Esprit Apparel Ltd (Parkzone) Padma Satel Arab Fashions Ltd. P & K Fashion Ltd. Luna Fashion Ltd.

Luna Complex, Joybangla road, Borobari, Gazipur, Dhaka

29th June 2014

Observations

Typical floor layout

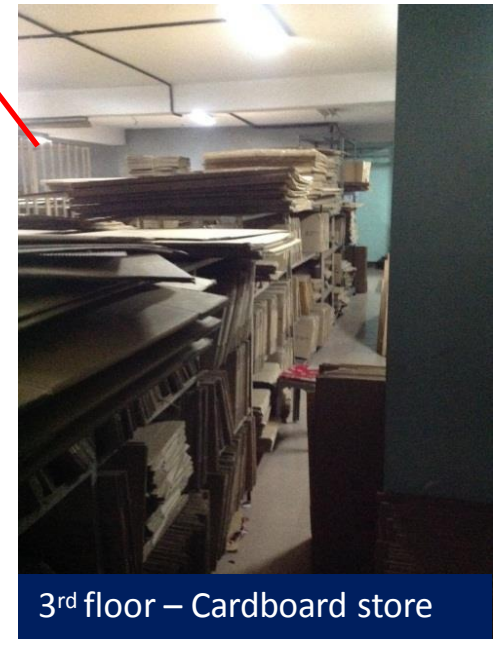
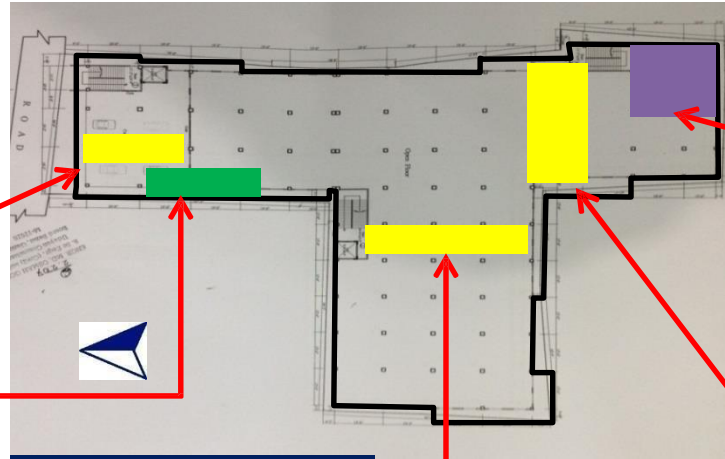
Cursory calculations indicate column stresses are high

Cursory calculations indicate that stresses are high in all columns. In particular, columns supporting cantilevers with toilet blocks are very highly stressed.

Toilet blocks supported by cantilever slabs

Item No.	Observation	Recommended Action Plan	Recommended Timeline
1	Cursory calculations indicate column stresses are high	Factory Engineer to review design, loads and column stresses for all columns.	Immediate - Now
2	Cursory calculations indicate column stresses are high	Verify insitu concrete strength using min. 4 no. 100mm dia. Cores taken from the ground floor columns (or existing cylinder strength data if available for 4 column locations).	Immediate - Now
3	Cursory calculations indicate column stresses are high	Verify existing reinforcement (steel grade, bar diameter and spacing) in columns.	Immediate - Now
4	Cursory calculations indicate column stresses are high	A Detailed Engineering Assessment of factory to be commenced, see attached scope	Immediate - Now
5	Cursory calculations indicate column stresses are high	Produce and actively manage a loading plan for all floor plates within the factory giving consideration to floor capacity and column capacity. This should include a safe level to which any water tanks can be filled.	6-weeks

6	Cursory calculations indicate column stresses are high	Detailed Engineering Assessment to be completed.	6-weeks
7	Cursory calculations indicate column stresses are high	Continue to implement load plan	6-months

Typical toilet block

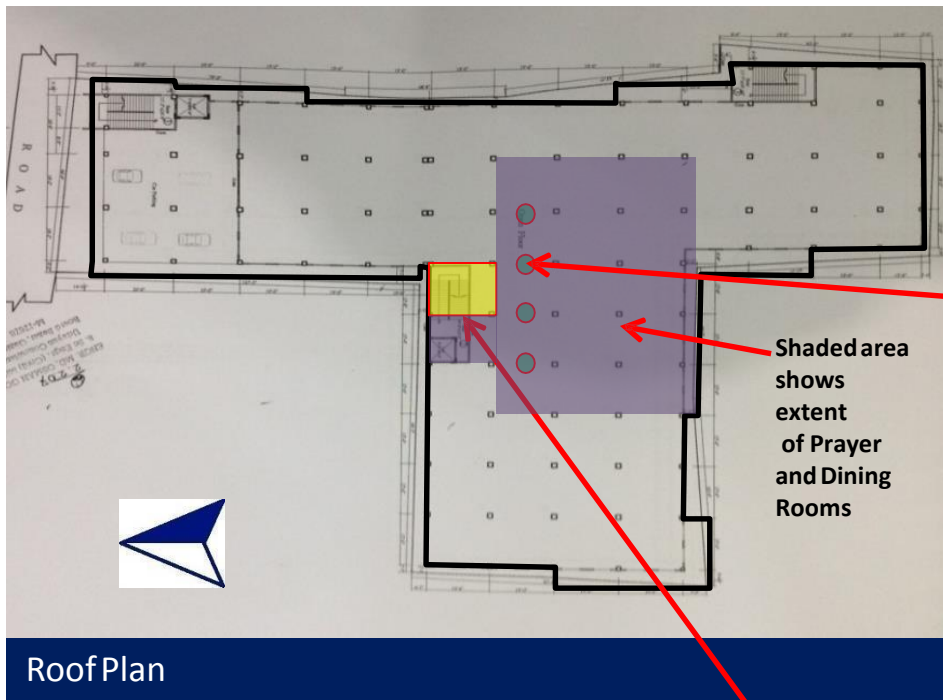
Localized areas of high loading

Areas of high loading on structure including cantilevers. No load management plan available for the building.

Item No.	Observation	Recommended Action Plan	Recommended Timeline
8	No floor load management plan	Produce and actively manage a loading plan for all floor plates within the factory giving consideration to floor capacity and column capacity (refer to Item 1).	6-weeks
9	No floor load management plan	Continue to implement load management plan.	6-months
10	Apparently non-engineered steel fire escape stairs on southern elevation of the EW building	Building engineer to review capacity of steel stair giving consideration to overall stability, section sizes used, stair bearing details and quality of fabrication	6-weeks
11	Apparently non-engineered steel fire escape stairs on southern elevation of the EW building	Building engineer to propose an necessary alterations/strengthening works	6-weeks
12	Apparently non-engineered steel fire escape stairs on southern elevation of the EW building	Ensure any necessary remedial works as advised by the Building Engineer are undertaken.	6-months

Typical Floor Plan

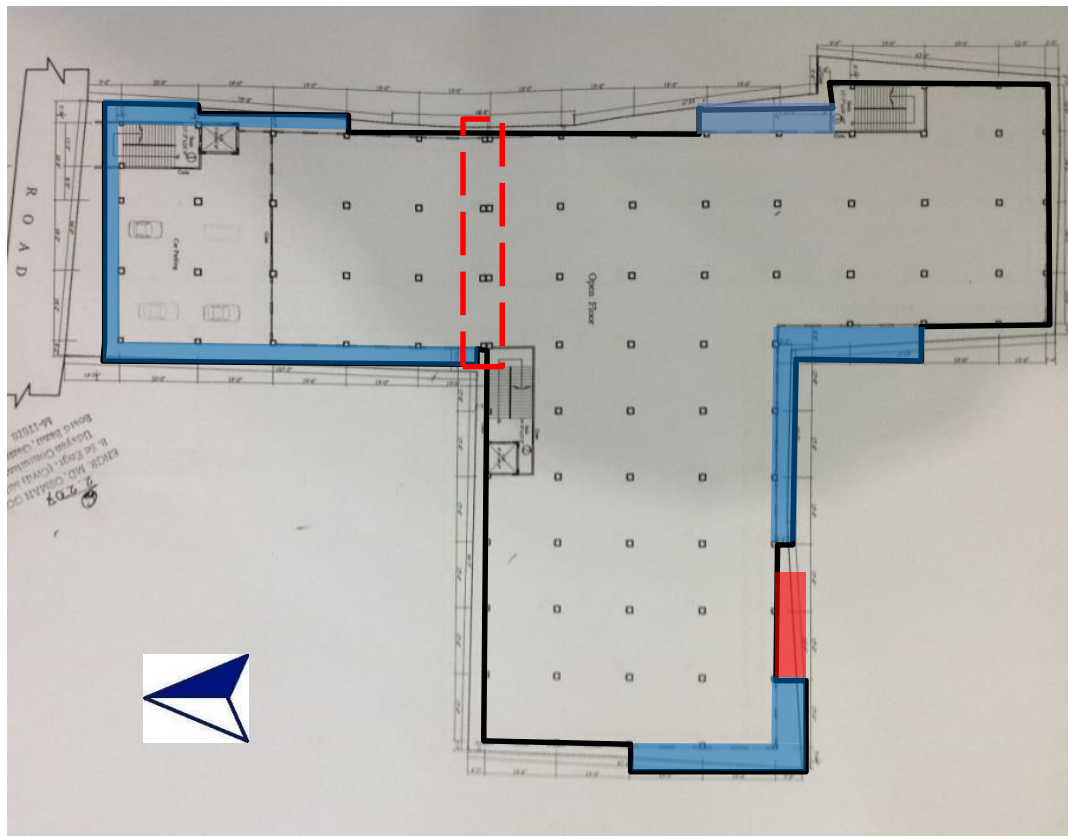
Apparently non-engineered steel fire escape stairs

The steel fire escape stairs appears to be non-engineered. The main issues observed are:

- Overall stability under vertical and horizontal loads does not appear to have been achieved
- Bearing of stair to concrete landing appears inadequate
- Section sizes appear to be slender
- Corrosion of the structure has lead to holes in the tube sections

Steel escape stairs and cantilever structure to the south of E-W Building

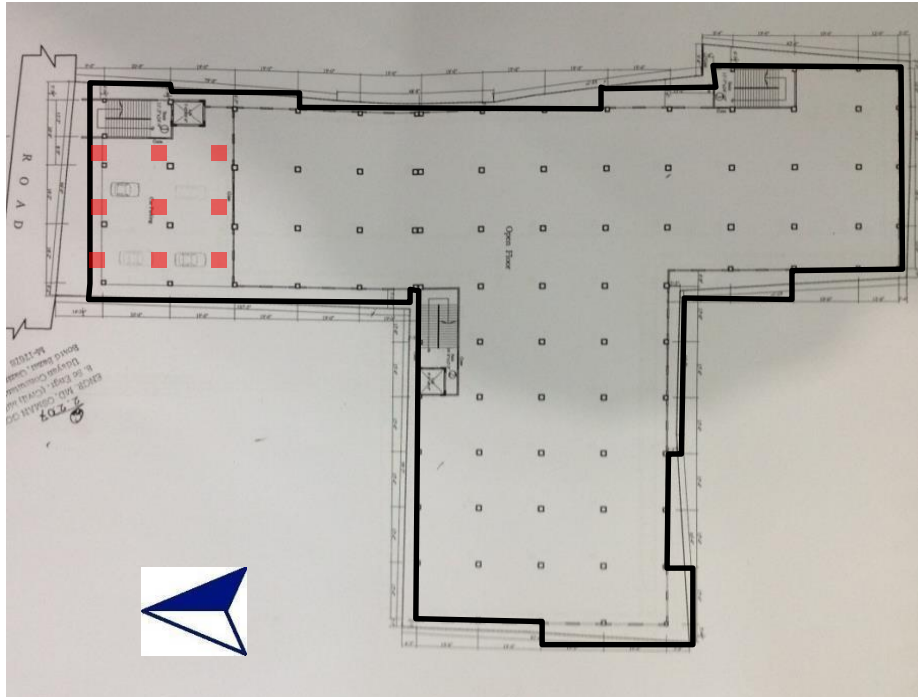
Inconsistencies between structural drawings and as built construction

- Double columns shown on drawings, single column built
- Cantilevers not on structural drawings
- Undocumented steel escape stairs
- Observed floor plate layout

13	Inconsistencies between structural drawings and as built construction	Building engineer to survey building and prepare As-Built drawings as part of the Detail Engineering Assessment (refer to Item 1).	6-weeks
14	Inconsistencies between structural drawings and as built construction	Building engineer to identify “as built” cantilever slab and supporting column reinforcement and confirm adequacy of the structural sections.	6-weeks
15	Column protection at ground floor delivery area	Building engineer to review capacity of column protection to vehicular impact and propose strengthening works if required	6-weeks
